**PD Modification Application: PRS 21-1277****Zoning Hearing Master Date:** N/A**BOCC Land Use Meeting Date:** January 13, 2022**Hillsborough  
County Florida**

Development Services Department

**APPLICATION NUMBER: PRS 21-1277**

## AGENCY REVIEW COMMENT SHEET

### 2.4 Proposed Site Plan (partial provided below for size and orientation purposes. See Section 8.2 for full site plan)

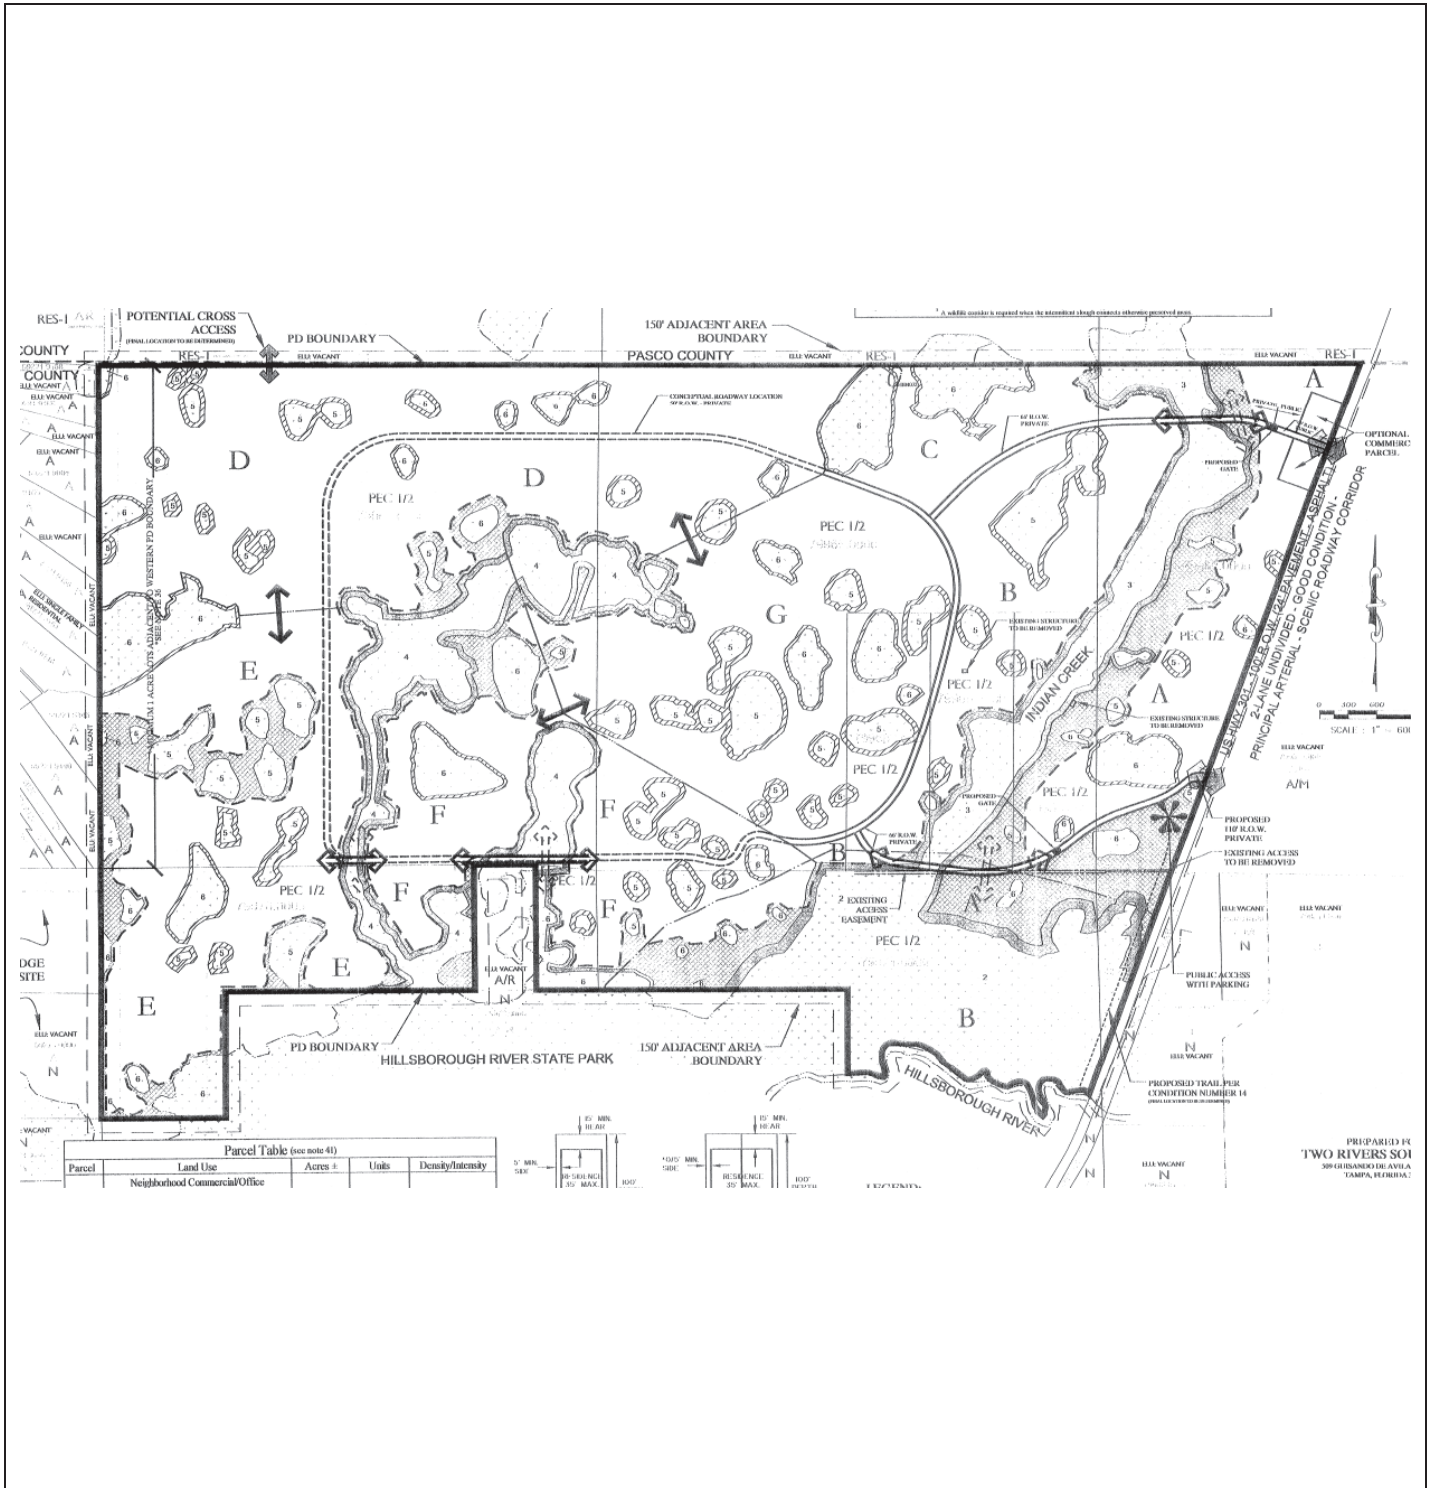
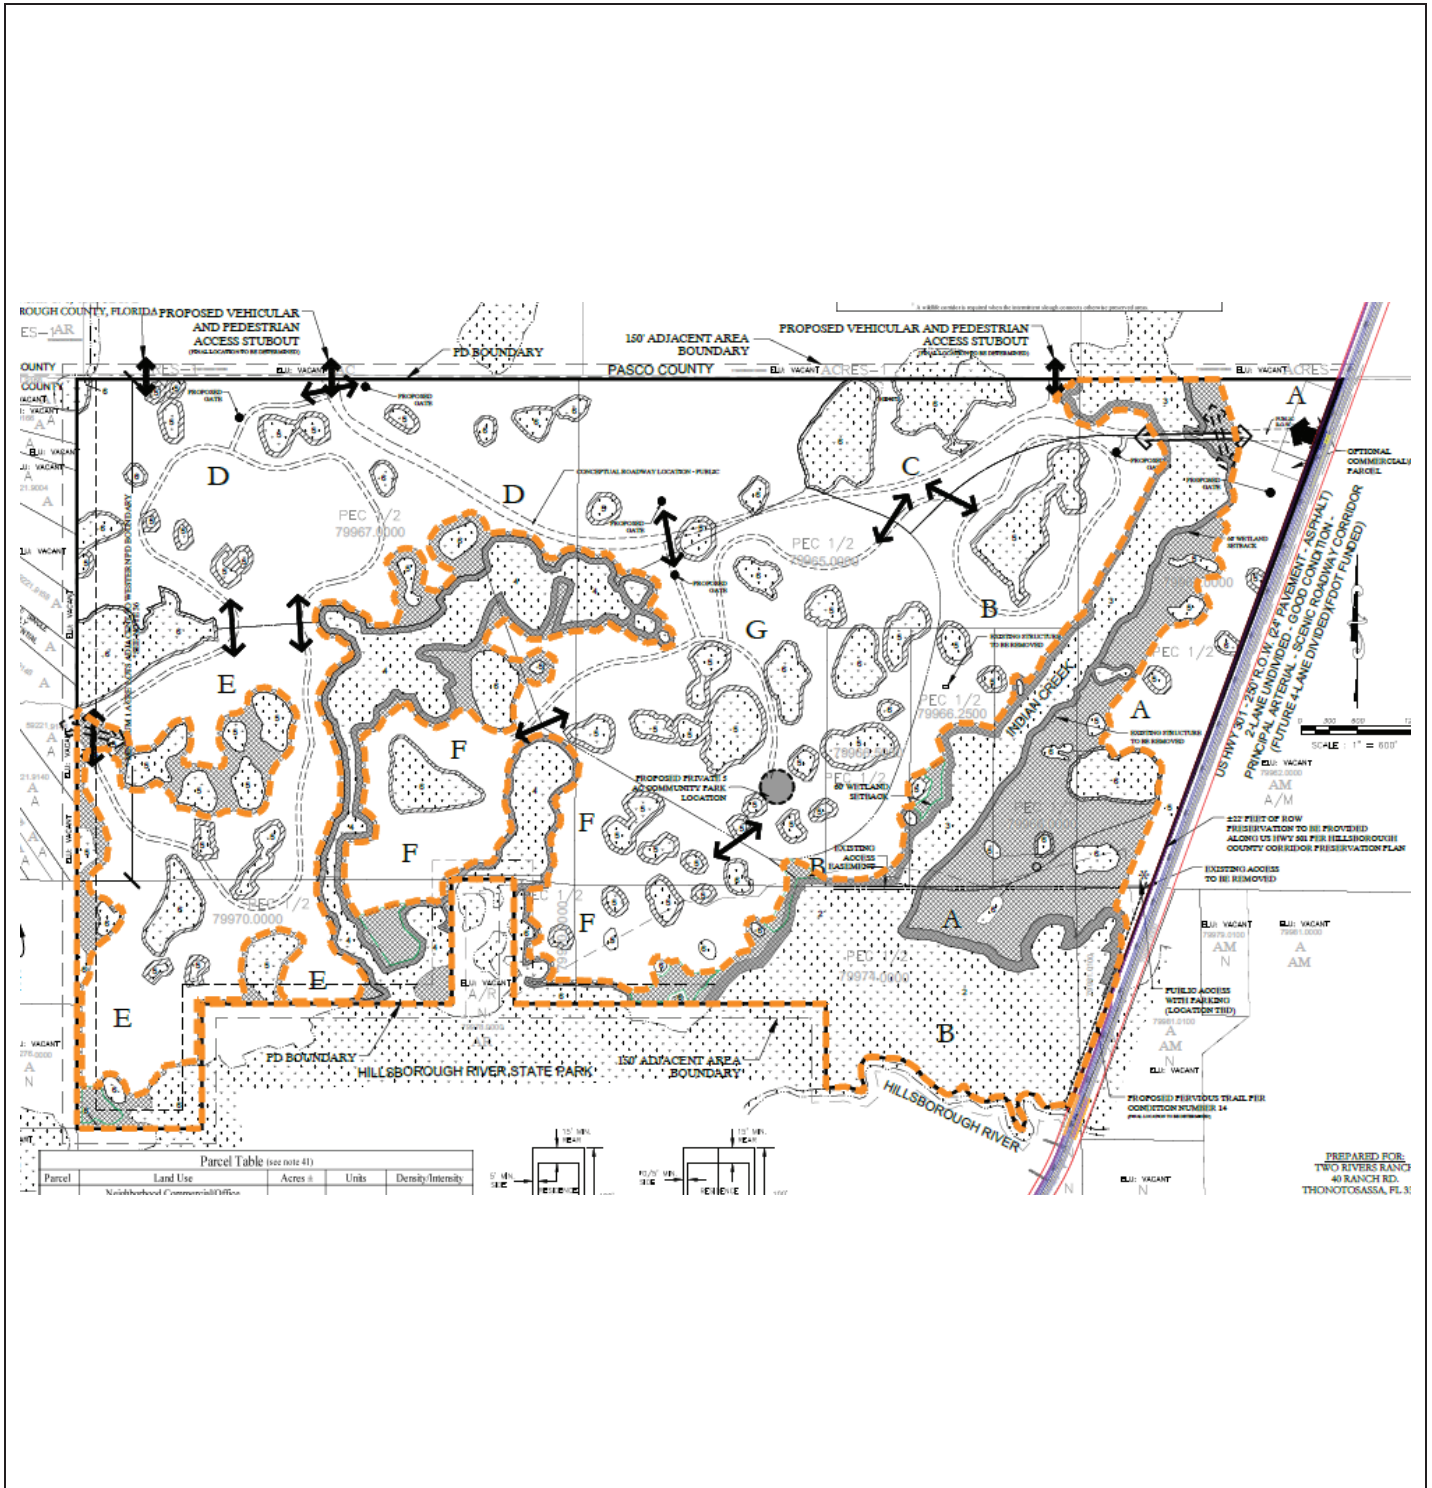
Transportation related changes include the internal circulation and access points. The proposed internal circulation pattern has been revised from a more general loop road to a more detailed layout that connects the various pods and curves throughout the property. The additional access points along the northern PD boundary are proposed for connection to a future residential development to the immediate north. This will increase the connectivity between the two projects. Per the applicant, the removal of the access point on US Highway 301 is proposed to avoid impact to the Significant Wildlife Habitat in this area and to lessen the number of crossings over Indian Creek. Transportation staff has reviewed these requests and offers no objections.

To comply with the intent of the PEC FLU Category, the project was originally approved to require a public access/parking area along US Highway 301 and a trail from that parking area to an overlook of the Hillsborough River within the subject PD. The location is shown in a specific area. The applicant seeks flexibility to allow a shift in this location southward or northward within the area delineated on the plan. This would provide flexibility for the least impactful area and a connection point approvable by FDOT. Natural Resources and Transportation staffs do not object to this request. Additionally, staff is proposing to modify the proposed condition regarding this amenity which currently does not provide a required time for its construction. Consultation with Planning Commission staff has recommended that this amenity be provided within the first phase of development to meet the requirements of the FLU category that allows the approved density.

The project proposes to re-locate Significant Wildlife Habit (SWH) areas and will continue to comply with the requirement of 272 acres of upland property to be preserved on the site. Natural Resources staff offered no objection to the revises site plan/change in the configuration of the preserved SWH area subject to updated/revised conditions.

### **Exhibit of Pasco County approved MPUD #RZ 7512 illustrating proposed connections to the subject property.**

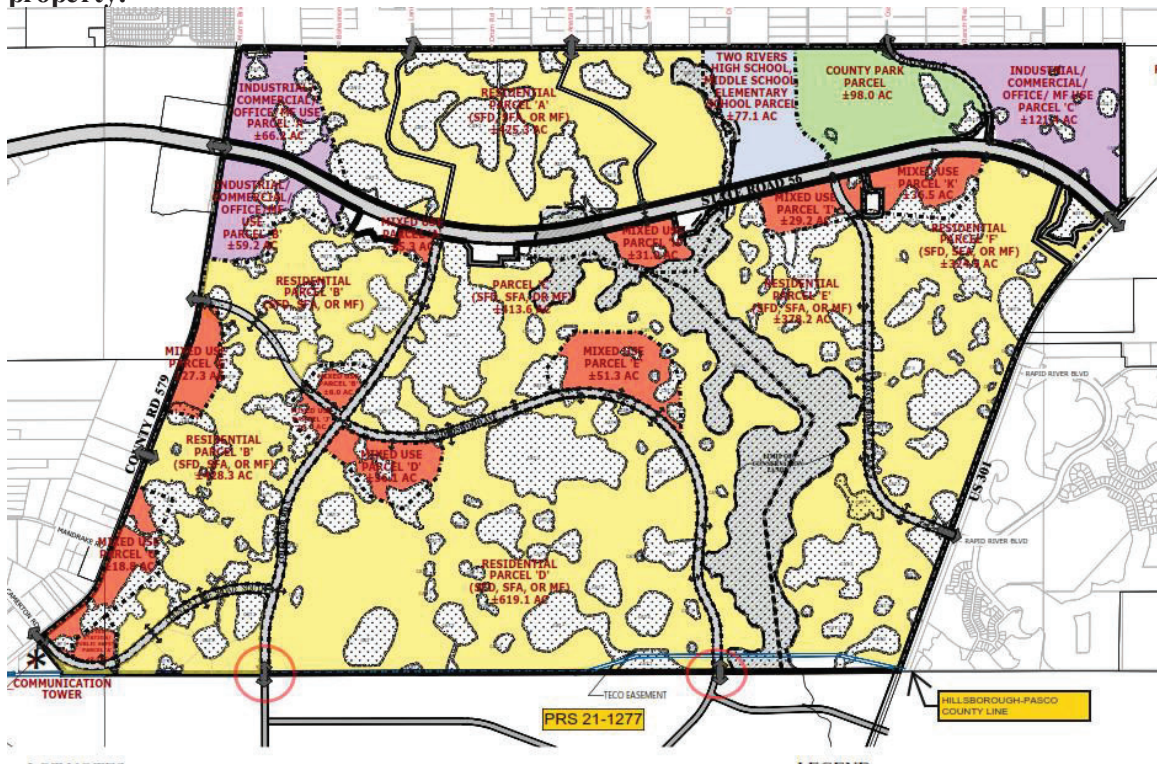
The proposed connections shown are generally consistent with the subdivision connectivity standards of LDC, Sec. 6.02.01 A. 13. through 16. as it relates to planning, designing and constructing:

The exact roadway alignments and connection locations are to be determined during the site/construction review process in coordination with Pasco County Planning Department. As such staff is recommending a condition of approval requiring the connections be constructed as stubouts with appropriate end-of-way treatments and signage until such time that the roadways connect.

- Proposed east-west public collector roadway shall be constructed to stubout to and connect with the planned Pasco County phase's roadway connection. In addition to any end-of-way treatment/signage required by the Manual of Uniform Traffic (MUTCD), the developer shall place signage which identifies roadway stub-outs as a "Future Roadway Connection".

### **Exhibit of Pasco County approved MPUD #RZ 7512 illustrating proposed connections to the subject property.**

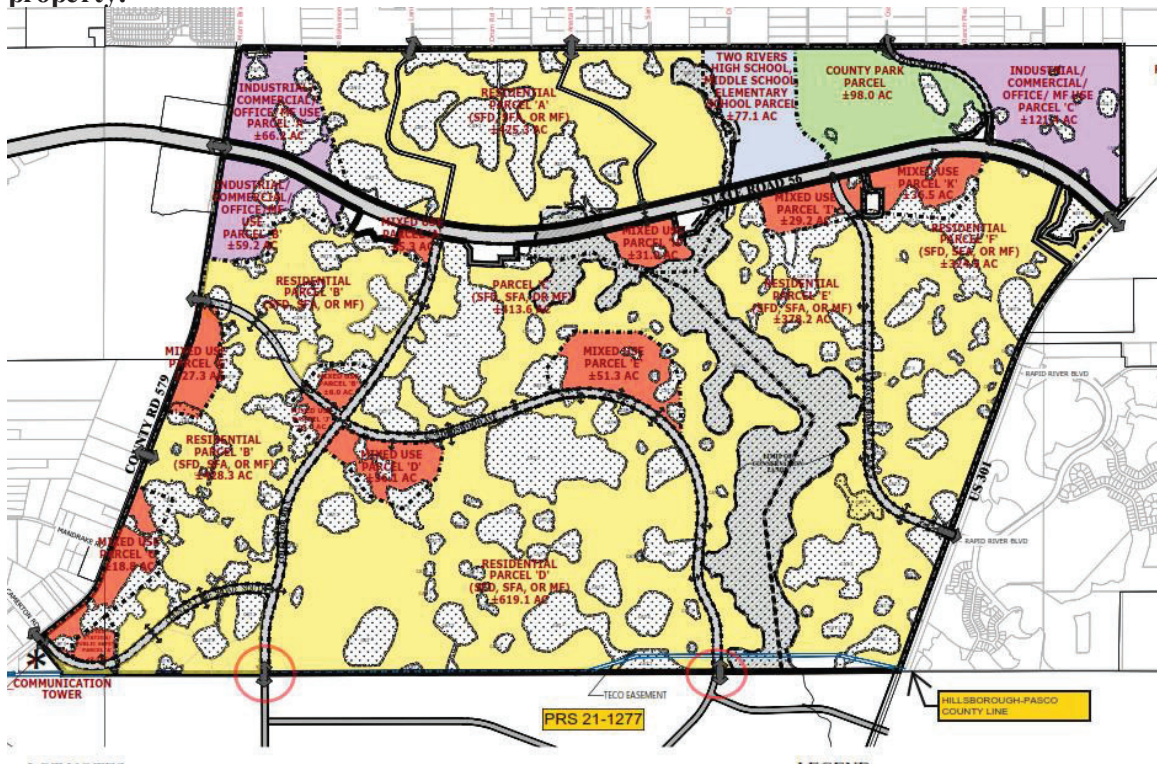
The proposed connections shown are generally consistent with the subdivision connectivity standards of LDC, Sec. 6.02.01 A. 13. through 16. as it relates to planning, designing and constructing:

- Proposed east-west public collector roadway shall be constructed to stubout to and connect with the planned Pasco County phase's roadway connection. In addition to any end-of-way treatment/signage required by the Manual of Uniform Traffic (MUTCD), the developer shall place signage which identifies roadway stub-outs as a "Future Roadway Connection".
